**Airworthiness Directive: 132**

**Date: December 13, 2004**

**Subject: Control Stick Connector**

**Models Effected: All S-4/5 Coyote I, S-9 Chaos and S-10 Sakota**

MD4492

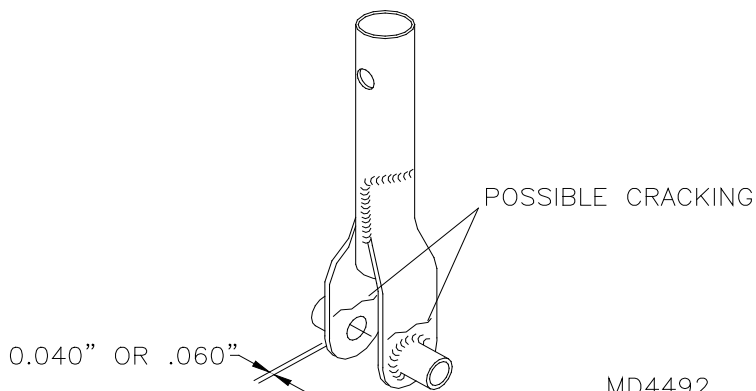
During a routine inspection the owner of an early model S-9 found the presence of cracks in the control stick connector. See figure #1.

Prior to the next flight, inspect for thickness of side plates and presence of cracks on control stick connector. See figure #1. Cracks may develop above the bolt pivot bushings in the control stick connect tube and other areas. Early model control stick connectors were produced using .040" thick 4130 steel and later upgraded to .060" 4130 steel. It is mandatory to replace the .040" control stick connectors with the .060" types. Please state pivot bolt diameter when ordering a replacement part. Thank you for your attention to this matter.

REPLACE .040" UNITS WITH .060" UNIT
